**Comments of the National Coalition for Advanced Transportation**

**Docket Nos. NHTSA-2018-0067, EPA-HQ-OAR-2018-0283, NHTSA-2017-0069**

**Subject:** Material for today's Light-duty GHG NPRM discussion.

# Summary points from EPA review of CAFE model (NPRM version) – Effect of EPA code revisions

# Growth in Fleet Size Due to Scrappage Model

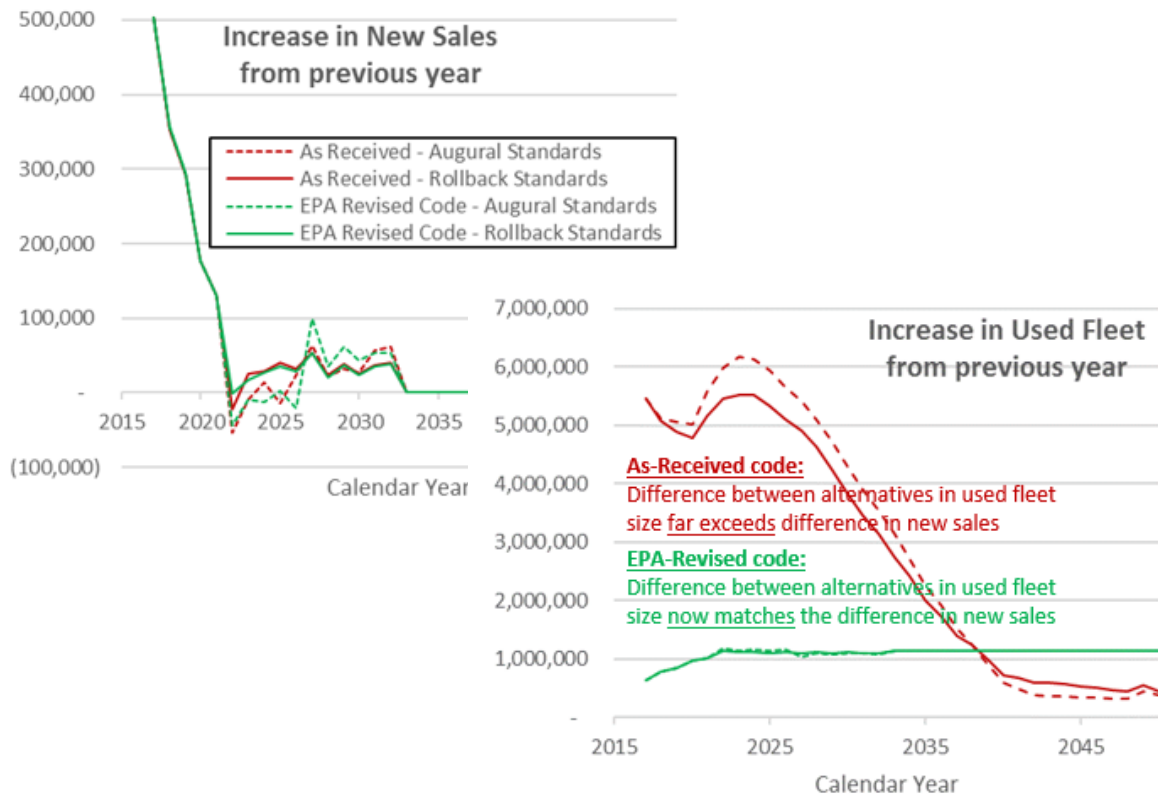
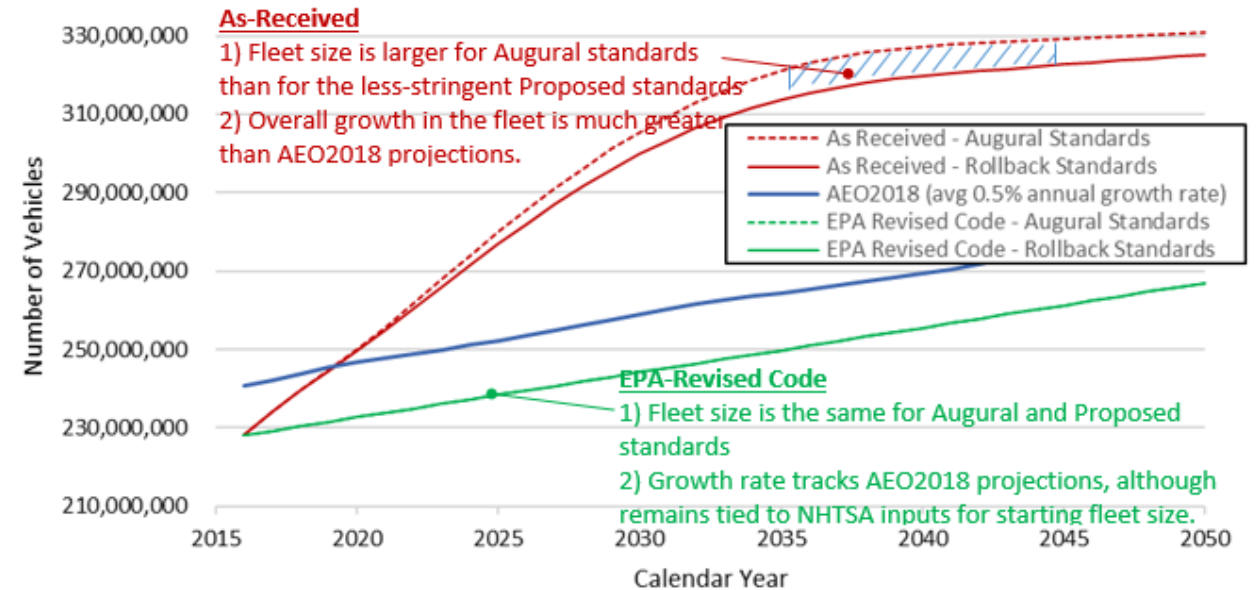
The new vehicle sales model produces small reductions in projected sales under the Augural standards, while the scrappage model projects an increase in fleet size that far outweighs the sales reductions (by a factor of 60:1.) The combined result is a fleet size that grows much more rapidly than AEO projections.

Specific the overall fleet growth as an input, and scale the scrappage rate curves (maintain the new sales model as is)

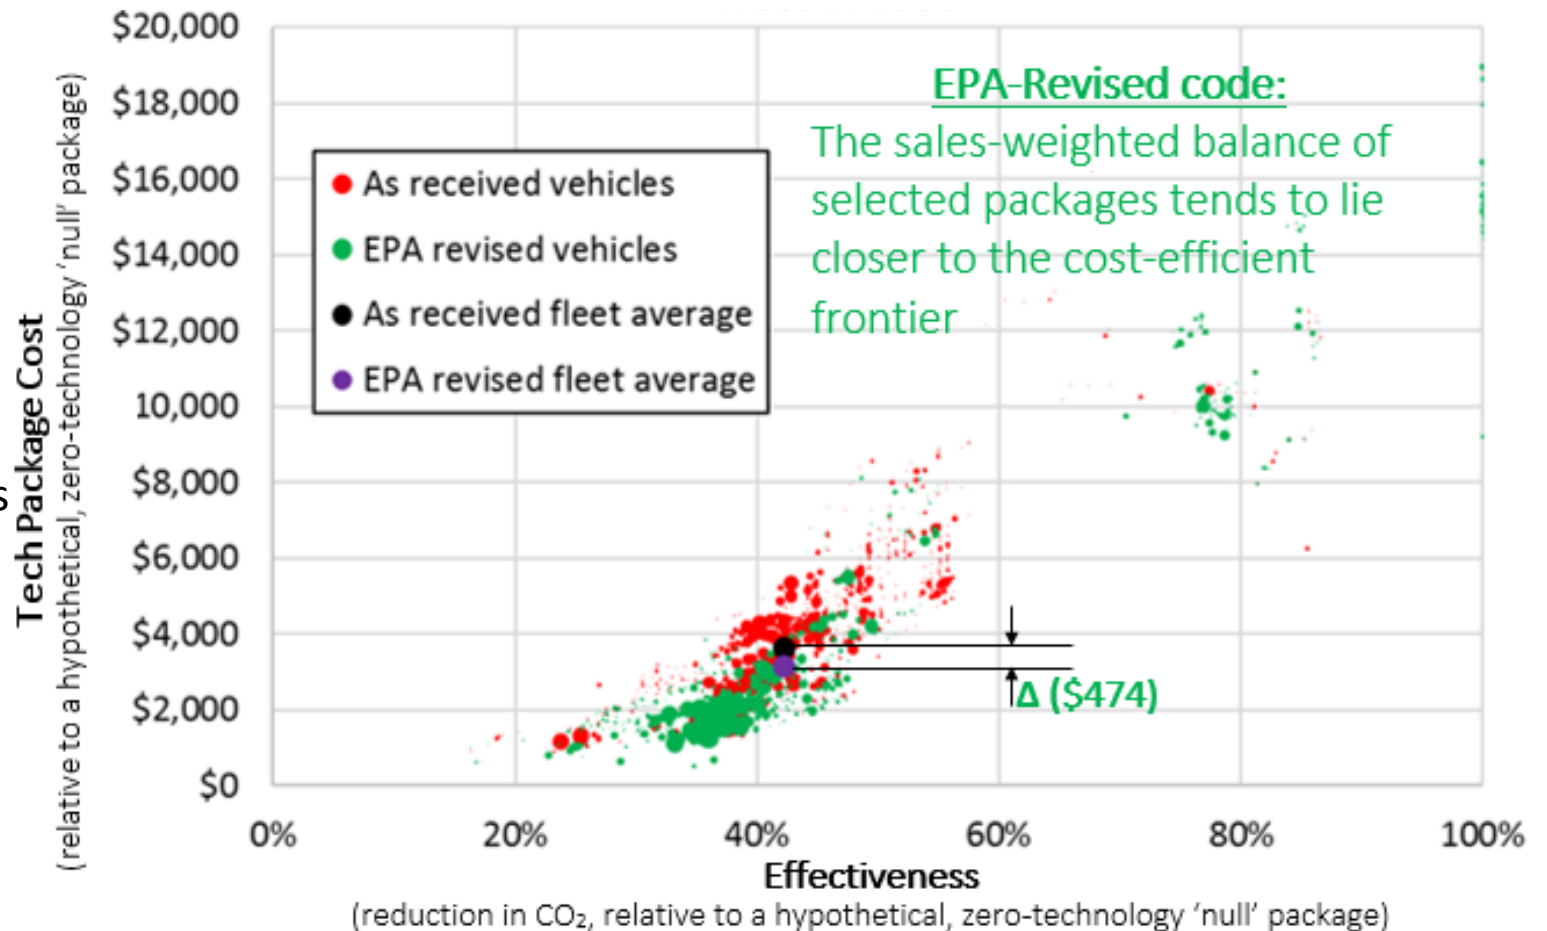
Cost-minimizing 'Efficiency' metric is used to select packages. Based on tech cost, fuel savings to consumer (2.5 years), consumer welfare loss from electrified vehicles, and manufacturer valuation of compliance credits

- 'Efficiency' metric revised so that net cost per gCO<sub>2</sub> credit is minimized, regardless of above or below vehicle target CO<sub>2</sub> value
- Results in significant reduction in tech costs, and more efficient utilization of available technology packages, including electrification

## MY2030 Required and Achieved CO2 levels for Each manufacturer regulatory car and truck fleets

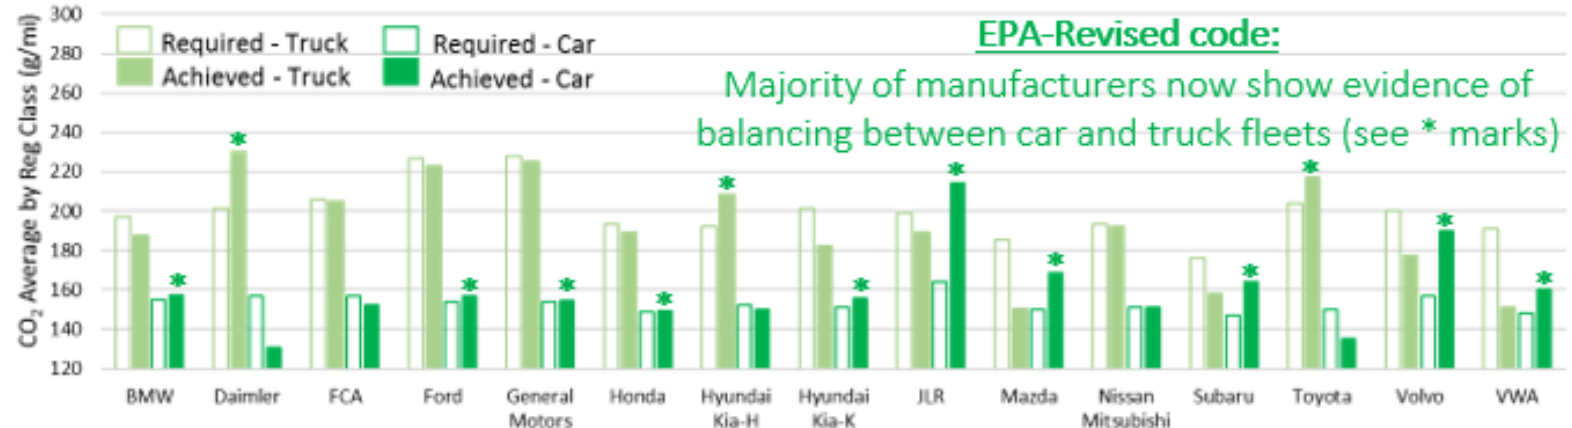
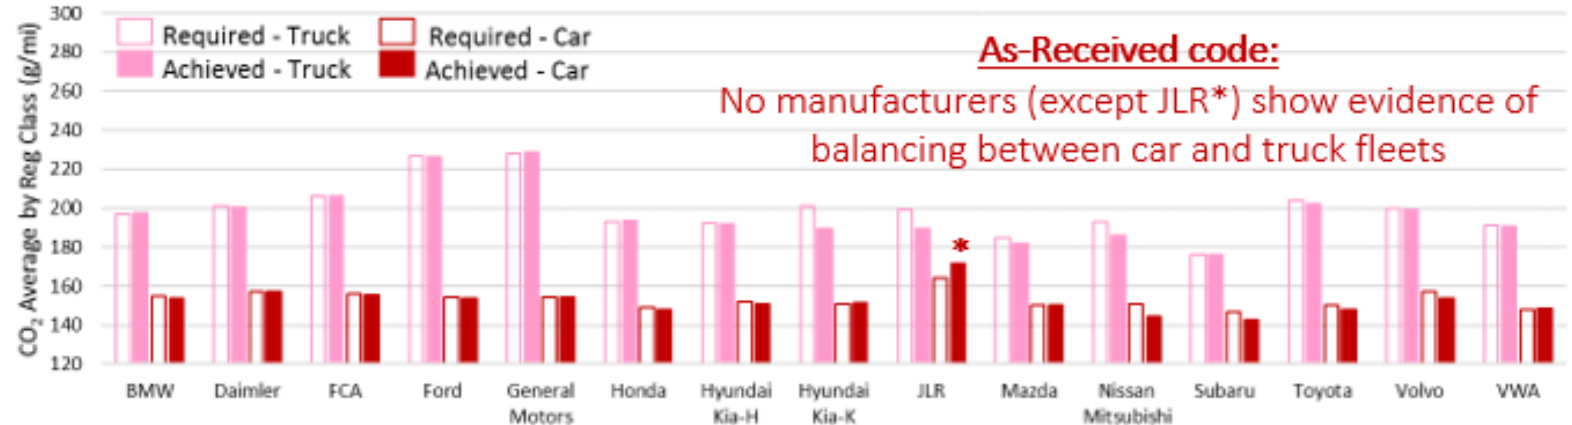
# Model logic for determining manufacturer compliance status inhibits fleet averaging (car-truck trading)

- Changed the manufacturer compliance status determination so that a positive sum of car and truck fleet credits will be appropriately considered as ‘in compliance.’ The results show broad transfer of credits between car and truck fleets, as would be expected.

**Figure 2 Year-over-year increase in new vehicle sales (left) and increase in used fleet size (right) using As-Received CAFE model (note the difference in y-axis scale)**

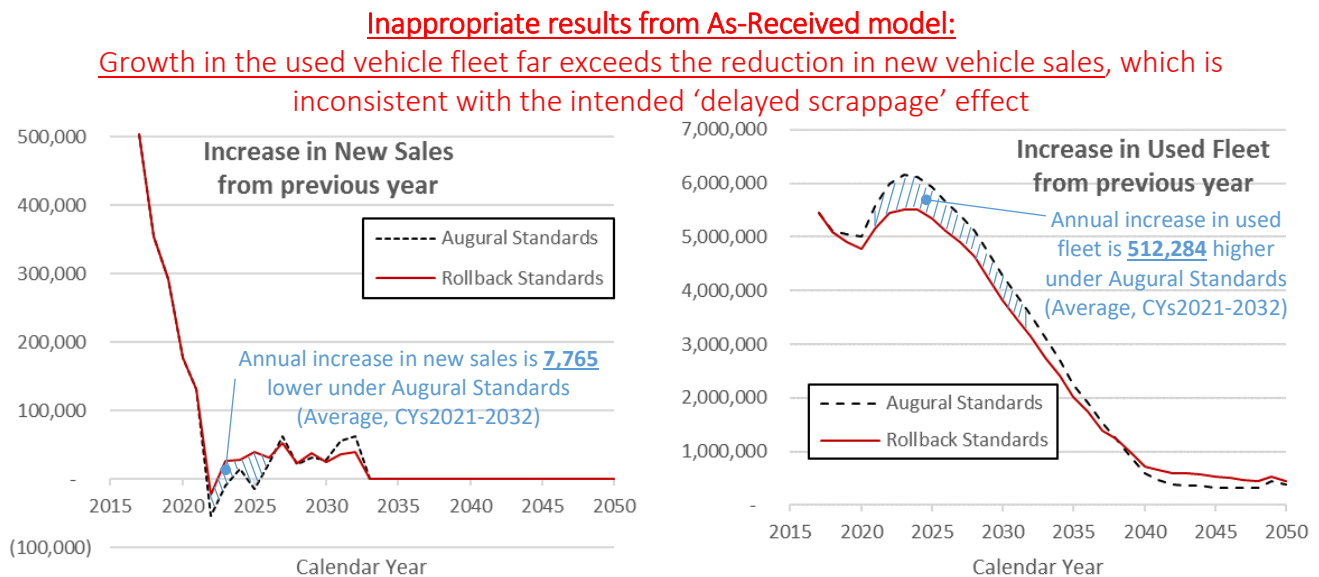
The effect of the disconnect between the new sales and scrappage models in the As-Received version is illustrated in Figure 2. Both the new sales fleet (i.e. vehicles of age 0) and the used fleet (i.e. vehicles of age greater than 0) generally increase year-over-year in the Augural and Proposed cases. For the used fleet, this is an expected trend since new vehicle prices and GDP increase for both the Augural and

While directionally those trends are logical, the difference in the magnitude of impact the Augural standards have on the new sales and scrappage models is difficult to justify. The As-Received model estimates that the Augural standards will reduce the year-over-year annual increase sales of new vehicles by approximately 8,000 vehicles on average between CY2021 and CY2032. However, during the same period, the As-Received model estimates that the used fleet will grow by an average of 512,000 vehicles per year, far exceeding the decrease in new vehicle sales. It’s hard to imagine any real-world scenario under which over 60 additional used vehicles are retained for each new vehicle that the sales model predicts will be unsold as a result of the higher new vehicle prices.

**Figure 3 Total fleet size in As-Received CAFE model (AEO 2018 0.5% growth rate shown for reference)**

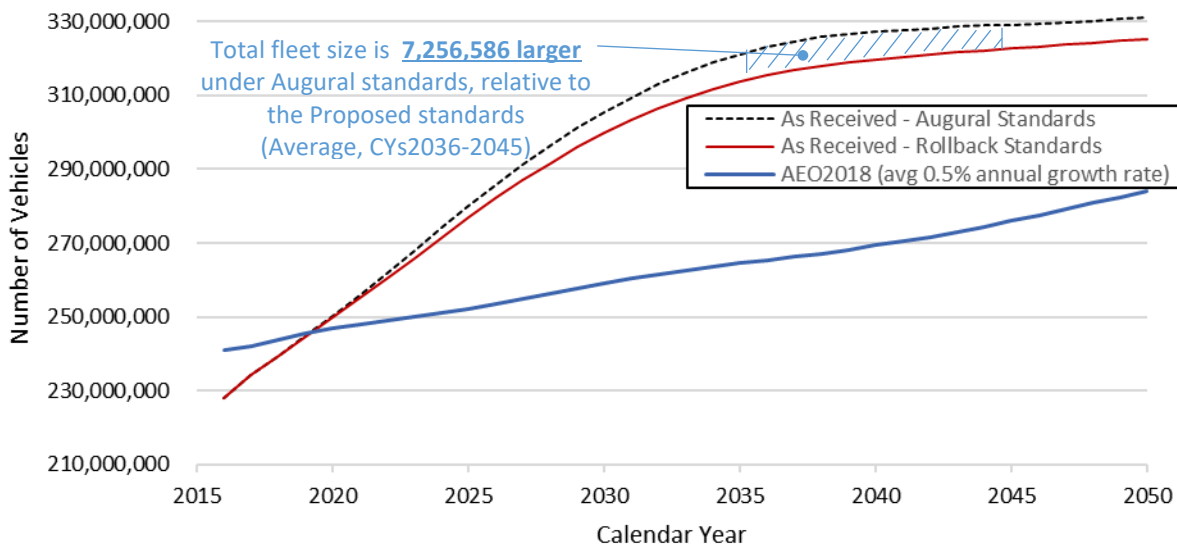
Figure 3 shows the combined effect of the new vehicle sales model and the scrappage model in the As-Received version of the CAFE model. A change in the overall fleet size due to the Augural standards might not in and of itself be problematic, as long as the VMT schedules are adjusted to account for overall travel activity that is distributed over a larger number of vehicles. However, the As-Received version of the model does not adjust VMT schedules, with the result that the additional unscrapped vehicles inflate total VMT proportionately. During the period over which the summary statistics for fatalities are reported in the draft NPRM (CYs 2036-2045), the difference in the estimated fleet sizes between the Augural and Proposed standards is approximately 7 million vehicles, or over 2% of the

Total Fleet size grows with increases in stringency and cost of new and used vehicles, which is not consistent with the basic principle of supply and demand

EPA modified the CAFE model to align with the NHTSA’s stated intent, so that the scrappage model predicts fleet composition, but does not dictate total fleet size. Our modified code allows the user to select a fleet growth rate (we have used the AEO value of 0.5% growth per year by default, but other rates could be used.) Our code then allows the model to run as usual to determine new vehicle sales and the composition of the used vehicle fleet. These values are then used to scale the size of the used vehicle fleet (maintaining the predicted composition) to achieve the user-provided growth in fleet size. This way the new vehicle sales are identical to the As-Received values, the used vehicle fleet has the identical composition as the As-Received values, but the fleet size grows at much more reasonable rates.

**Figure 4 Change in VMT due to 20 percent rebound with As-Received model, Proposed standards case (change shown is relative to 0 percent rebound)**

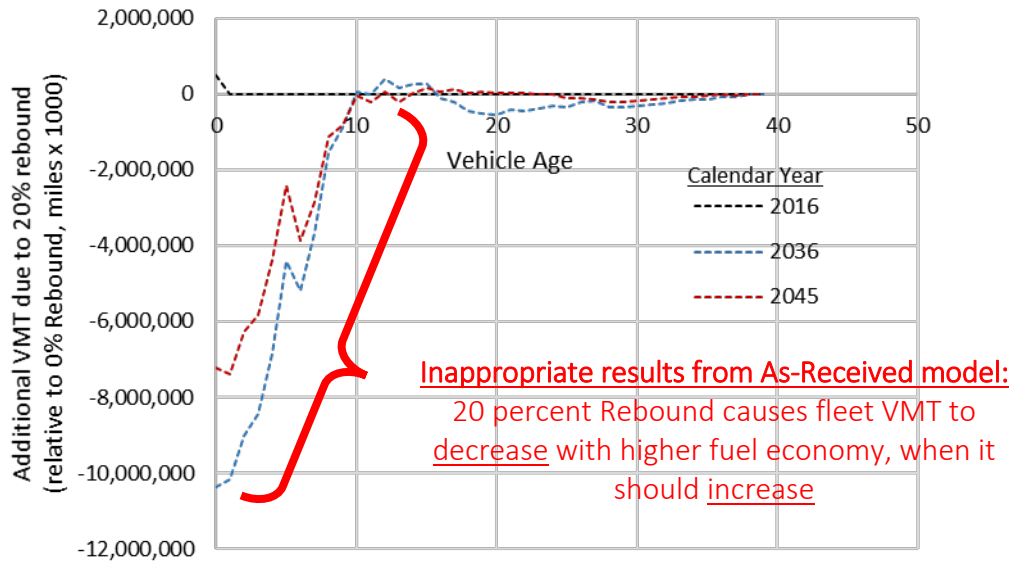
One of the problems with the implementation of the rebound calculations in the code of the As-Received model is illustrated in Figure 4 for the Proposed standards. In this case, the inclusion of 20 percent rebound causes a reduction in VMT in future calendar years, despite the fact the Proposed standards produce a fleet with higher fuel economy and lower cost per mile than the baseline (MY2016) fleet. This result is clearly inappropriate, since by definition the rebound effect should result in more miles driven as cost per mile decreases.

Figure 5 CPMrate variation by vehicle age and fuel economy improvements during redesign of 10 percent (left panel) and 50 percent (right panel)

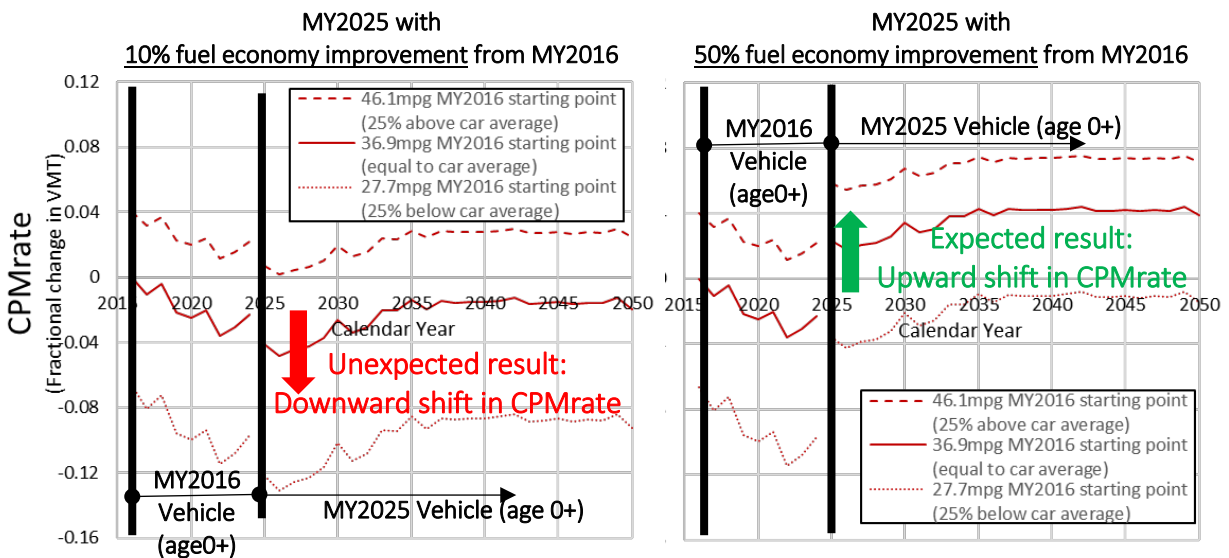
Figure 5 gives a closer view of the CPMrates determined from Equation 1 for three example vehicles, with MY2016 versions which maintain a constant fuel economy at levels equal to, 25 percent above, and 25 percent below an average MY2016 car.<sup>9</sup> These values are maintained until a MY2025 redesign, when the fuel economy is improved by either 10 percent (left panel) or 50 percent (right panel) compared to the MY2016 versions.

One notable observation is how the CPMrates vary by calendar year as the individual vehicles age. This is unexpected, since the CPMrate is applied to the annual mileage values that already account for the progressive decline in the miles driven each year as vehicles age. What the age- or year-related phenomenon this variation in CPMrate would be intended to represent is not clear. Another notable observation is the inconsistency in the direction of change in CPMrate of the new MY2025 vehicle, relative to the 8-year old MY2016 vehicle in CY2024. When the MY2025 vehicle is 50 percent more fuel efficient than MY2016 (right panel of Figure 5), the CPMrate shifts upward, resulting in higher VMT for the vehicle with greater fuel economy as would be expected. However, when the MY2025 vehicle is only 10 percent more fuel efficient than MY2016 (left panel of Figure 5), the CPMrate shifts downward. This tendency to produce VMT reductions for newer vehicles with moderate levels of fuel economy improvement is consistent with the inappropriate VMT results shown in Figure 4 above, indicating that this issue is caused by the calculation of CPMrate within the CAFE model.

**Figure 6 Change in VMT due Augural standards, with 0 percent rebound (relative to Proposed standards)**

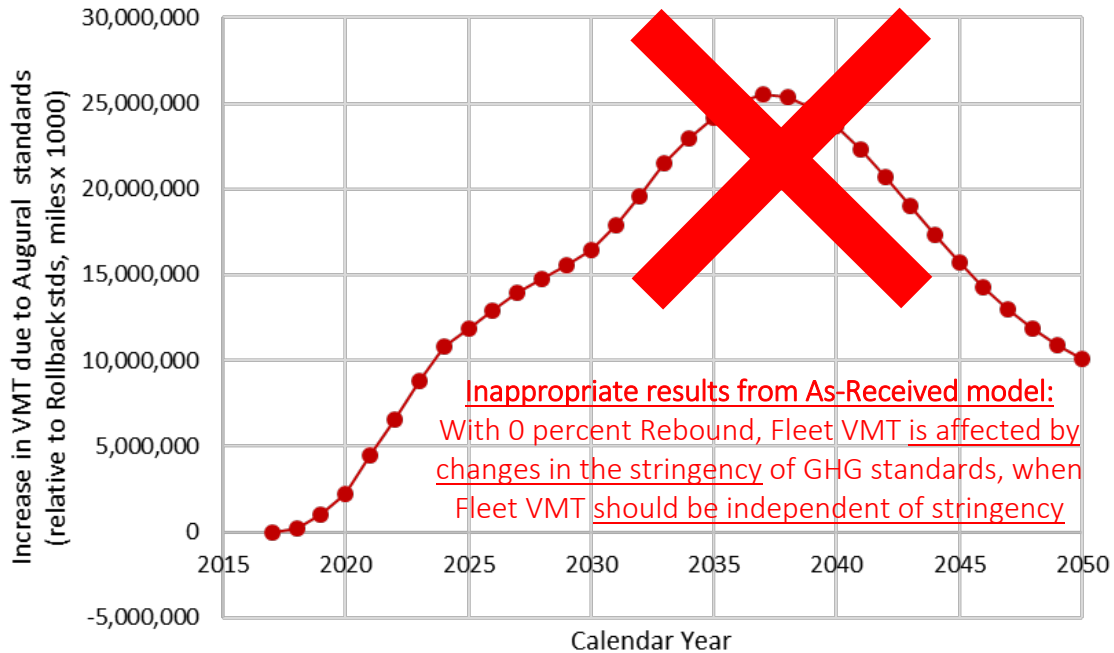
In addition to the problems described above with the As-Received model’s implementation of the rebound effect, an additional inconsistency between VMT estimates generated by the model and the specified rebound value became evident when we looked at the VMT results for alternatives with different stringencies, holding rebound at 0 percent.<sup>10</sup> With no rebound, we would not expect to see any change in total VMT, since by definition rebound is measured as the change in VMT for a given change in fuel cost per mile. However, even with 0 percent rebound, the As-Received model does produce total VMT values that are influenced by stringency level. See Figure 6, below. We believe that this zero-rebound VMT growth is an artifact of the disconnect between the sales model, scrappage model and mileage accumulation schedules described with Issue #1. And while this problem is not directly related to the model’s calculation of the rebound effect, it points to the importance of carefully considering how the various elements are integrated when making changes or additions to a model.

In total, the As-Received model 1) inappropriately incorporates a vehicle age-related effect due to rebound, 2) exhibits directionally incorrect VMT changes in response to fuel economy improvements, and 3) produces a VMT response to changes in stringency even when the rebound value is set to 0. We conclude that the model’s implementation of the rebound effect is inappropriate, and that the model code produces VMT values that are inconsistent with the 20 percent rebound value that is specified in the input files. As with the problems described for the Scrapage Model in Issue #1, resolving the problems with the CAFE model’s implementation of the rebound effect is critically important. An inappropriate accounting of the rebound effect will produce unreliable VMT estimates, which in turn will produce unreliable estimates of net fuel savings, emissions costs, fatalities, etc., making it impossible to accurately evaluate and compare the various policy alternatives.
